PLANNING COMMISSION
DATE: 12/14/15
AGENDA ITEM: 4a– PUBLIC HEARING
CASE # 2015-19

The Planning Commission is being asked to consider a Rezoning request and a Conditional Use Permit from Arbor Glen Senior Living LLC for an 84-unit Congregate Housing (Senior Living) to be located on 3.77 acres of land at the northeast corner of Lake Elmo Ave N (CR 17) and 39th St North. The Comprehensive Plan guides the site as Village Center- Mixed Use VMX Zoning District. The site has urban services available. Staff is recommending that the public hearing be opened for public and planning commission comments, then extended to the January 25th meeting date to provide adequate time to process a comprehensive plan text amendment concurrent with this land use request.

To: Stephen Wensman, City
Cc: Planner Ben Gozola, Senior Planner, Sambatek
From: Jack Griffin, P.E., City Engineer

Engineering has reviewed the revised Site Plans for the Arbor Glen Senior Living Building. The submittal consisted of the following documentation prepared by Ayres Associates:

INSPECTION & MAINTENANCE

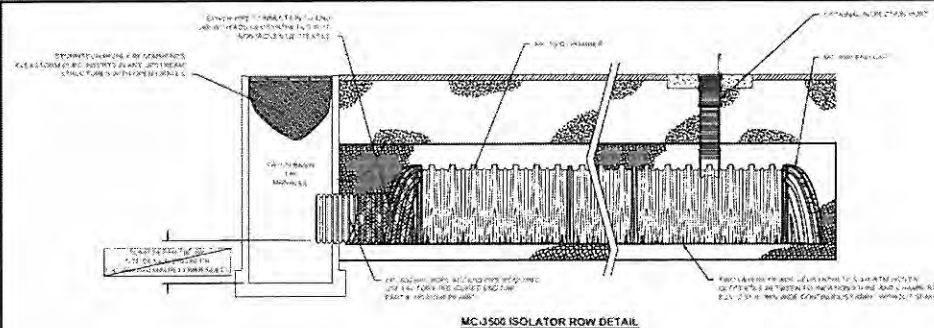
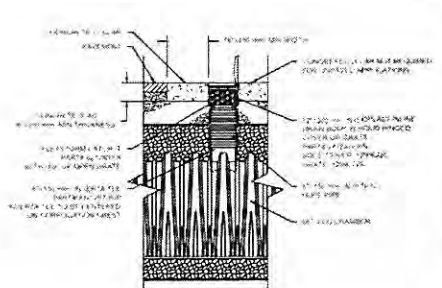
2. The Stormwater Management Plan was received, dated November 17, 2015 and includes the following:
 - The plan proposes an on-site filtration basin together with a StormTech underground infiltration chambers. Due to on-site soils being marginally suitable for infiltration, drain tile underdrains have been included in the plans.

EXISTING CONDITIONS, DEMOLITION AND TREE PRESERVATION PLAN

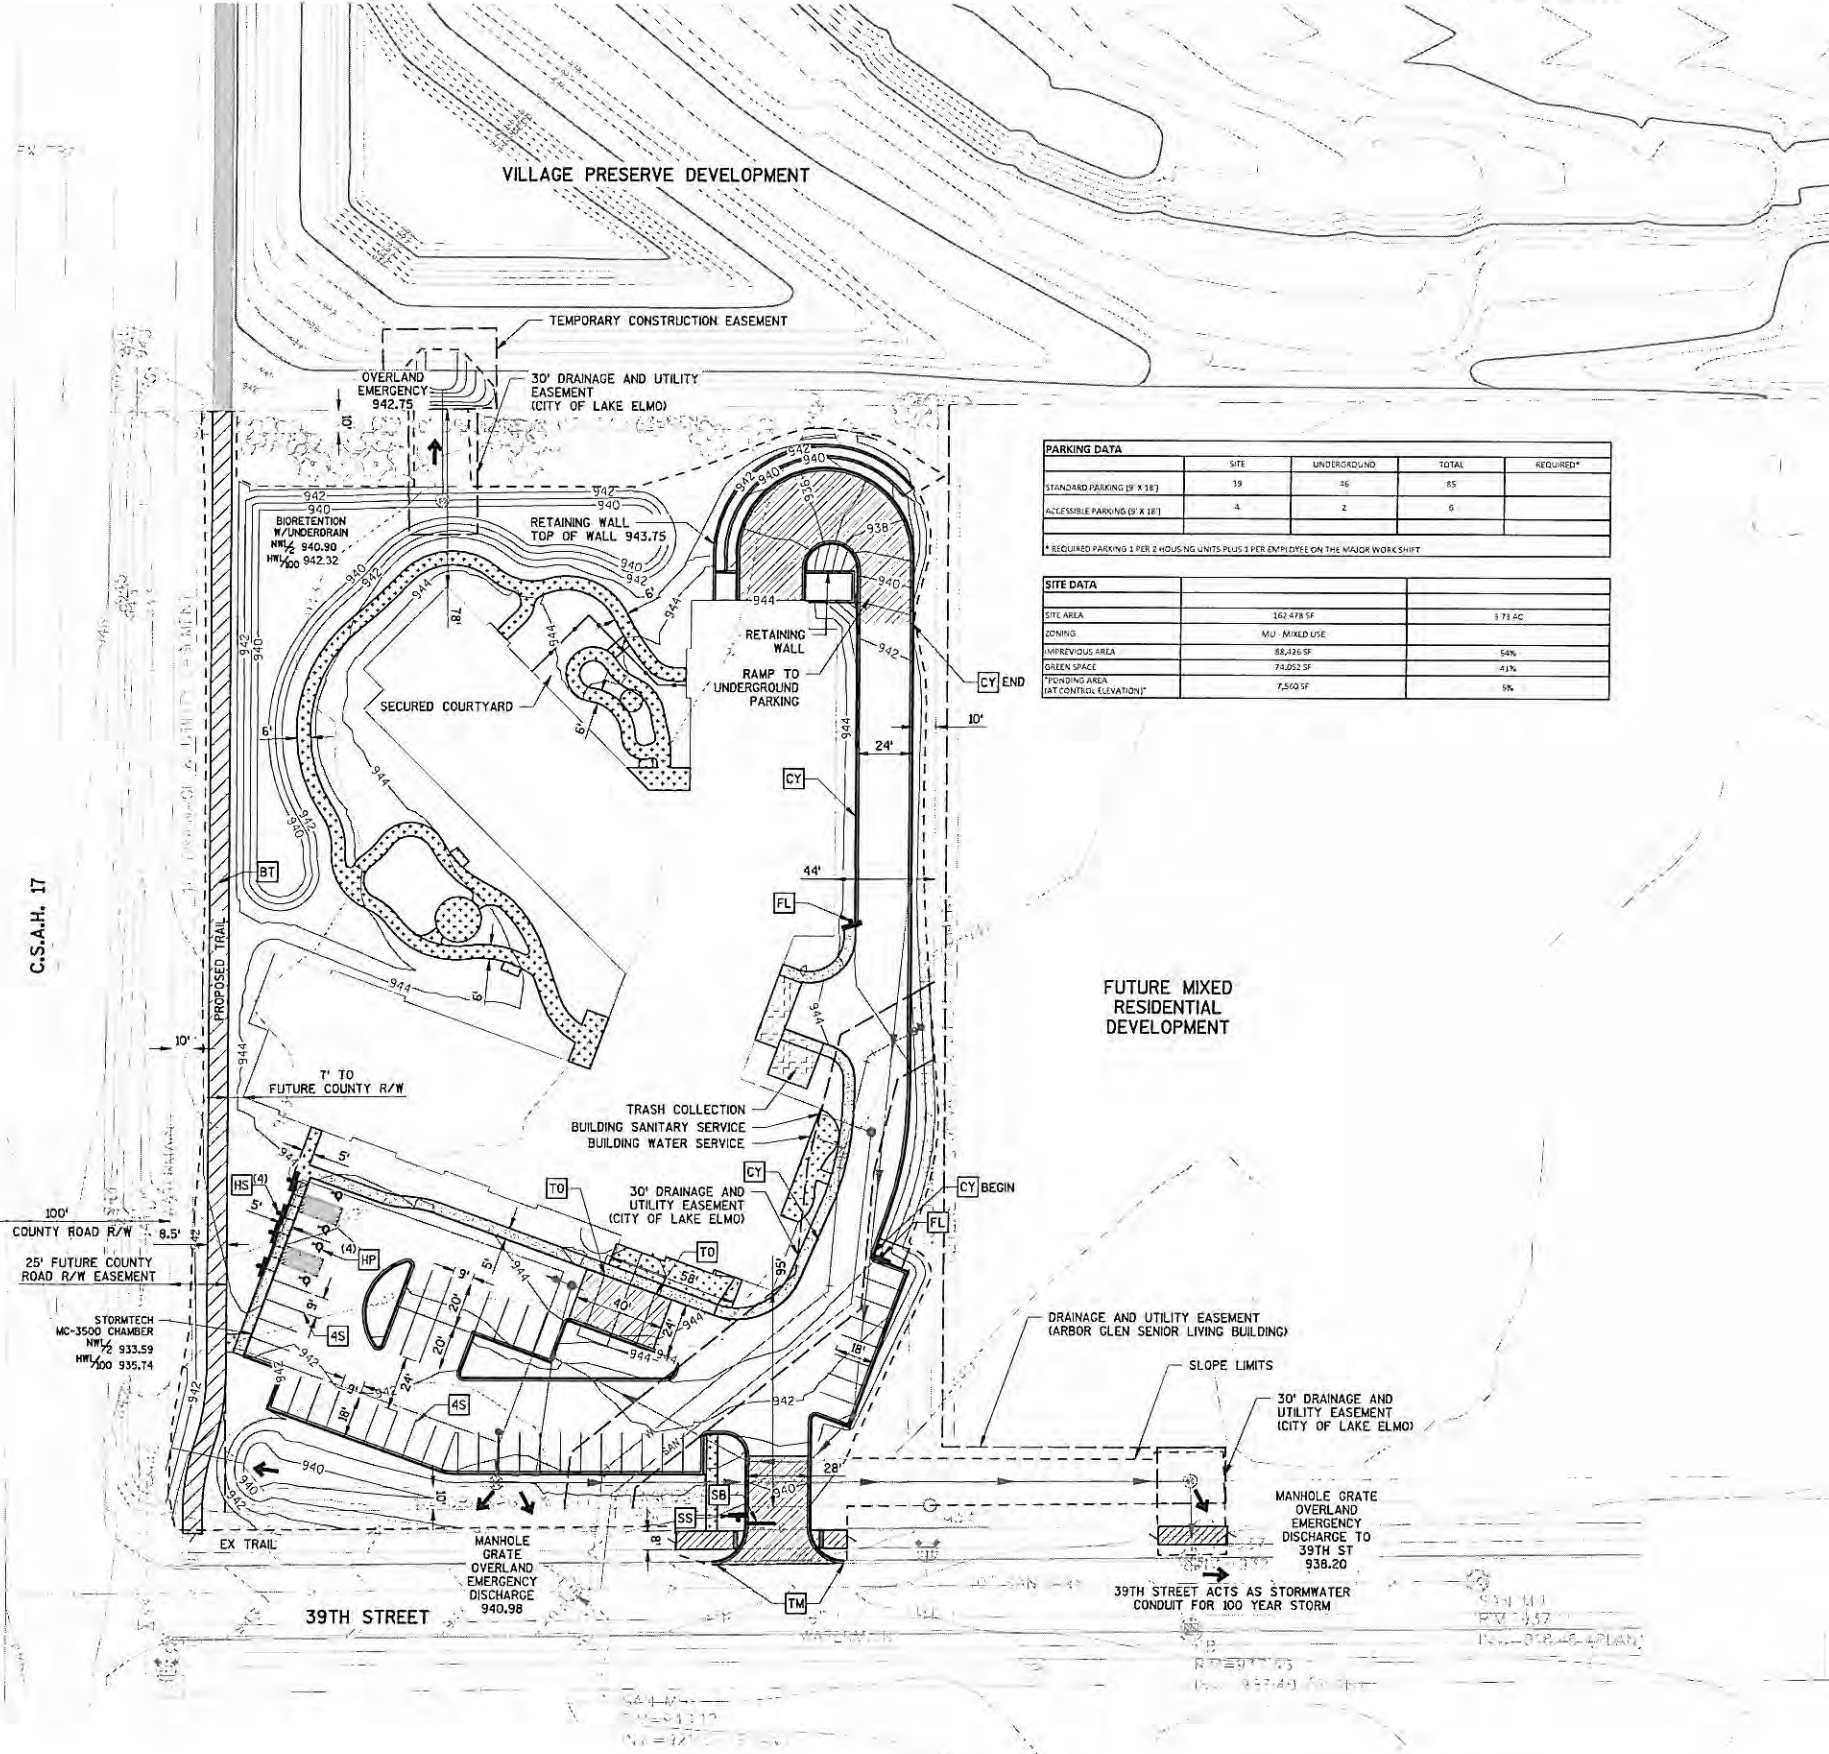
No tree preservation plan was submitted with the application as required. There are 10 Spruce that qualify as "significant trees" and 22 clump Amur Maple on the site survey. Tree preservation ordinance allows for 30% removal of significant trees, or 3 trees. The demolition plan indicates that 6 - 14" Spruce and 6 clump Amur Maples will be removed. According to the tree preservation code, a mitigation plan is required. The required tree mitigation is calculated as follows:

LANDSCAPE PLAN

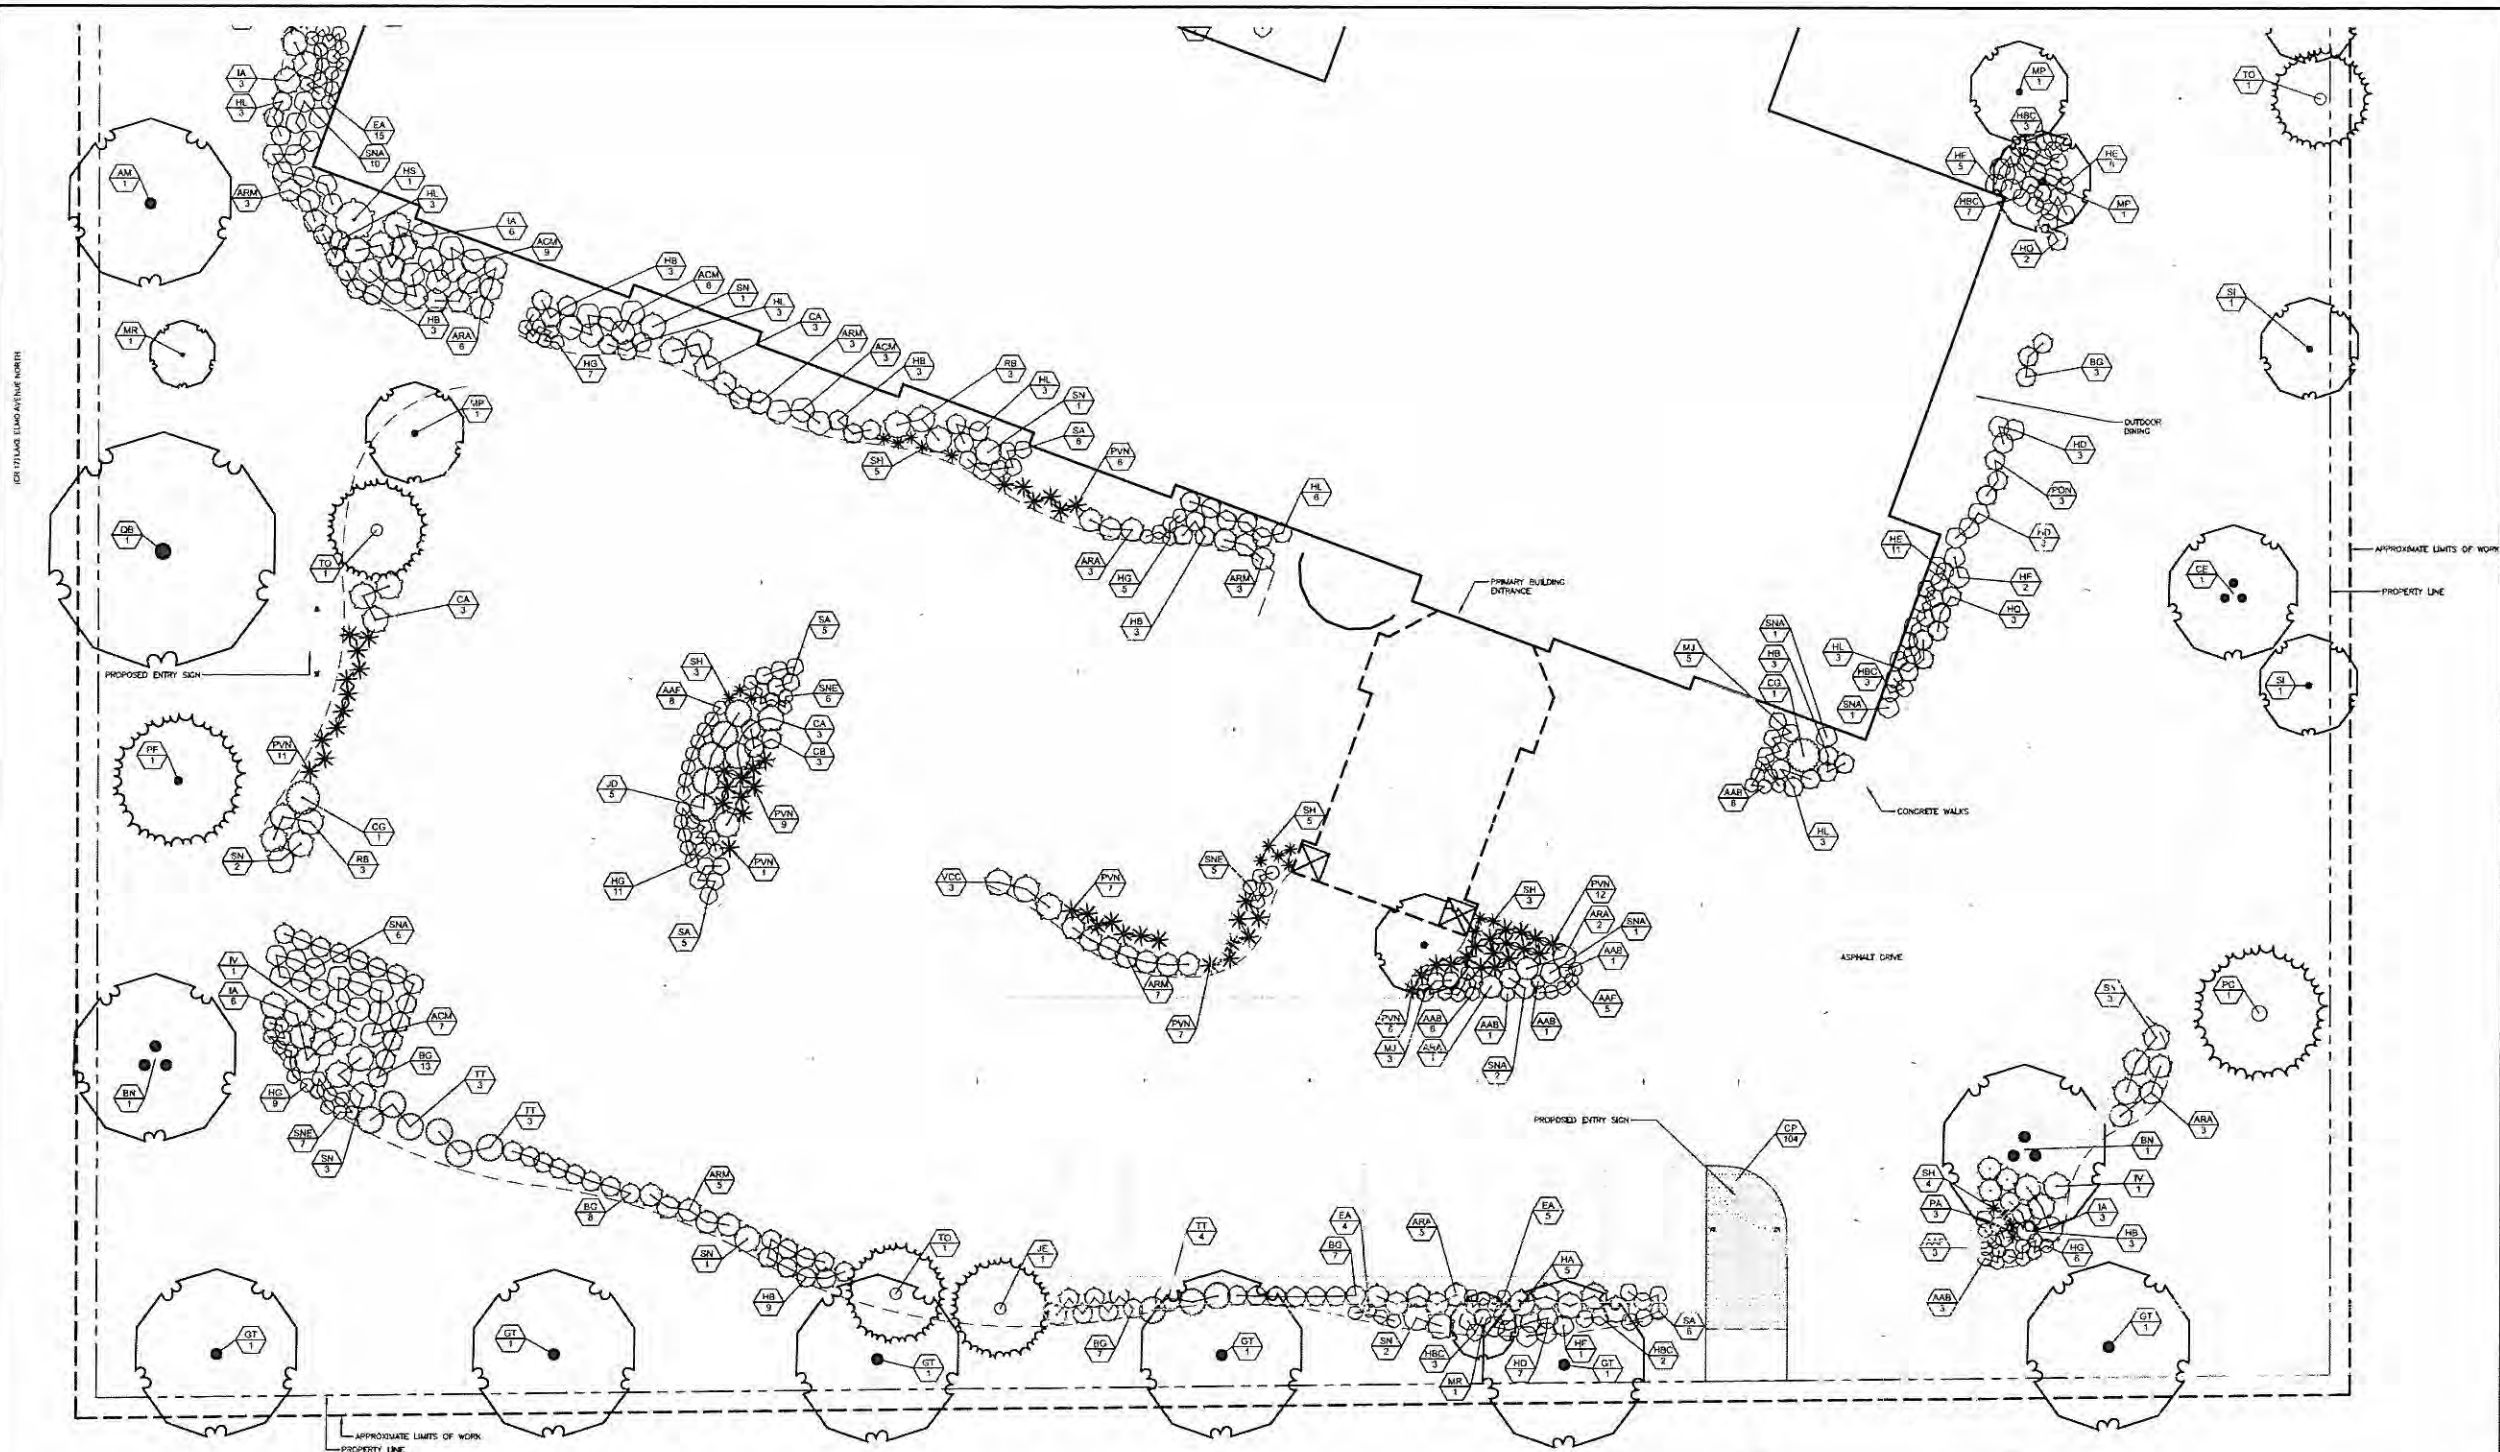
The landscape plan proposes 71 trees: 16 deciduous trees, 21 coniferous trees, and 34 ornamental trees. The proposed trees and shrubs meet the requirements for size and variety including requirements for interior parking lot landscaping.

The landscape ordinance requires screening between differing land uses. The majority of the existing trees on site are located along the north perimeter which will provide a natural screen between the differing uses. In addition, the landscape plan shows additional landscaping within that zone.

The landscape ordinance also requires screening of parking from the public right-of-way with 50% opacity with a 3.5'-4' height. The landscape plan shows extensive screening between the parking lot and rights-of-way with a mix of deciduous and coniferous shrubs, grasses and perennials.

In general, the proposed landscape will be aesthetically pleasing with rich in diversity of plant materials which exceeds the minimum landscape requirements. Staff has identified a few plant selections that it will recommend changing and will recommend eliminating the weed control fabric under the mulch in planting beds.
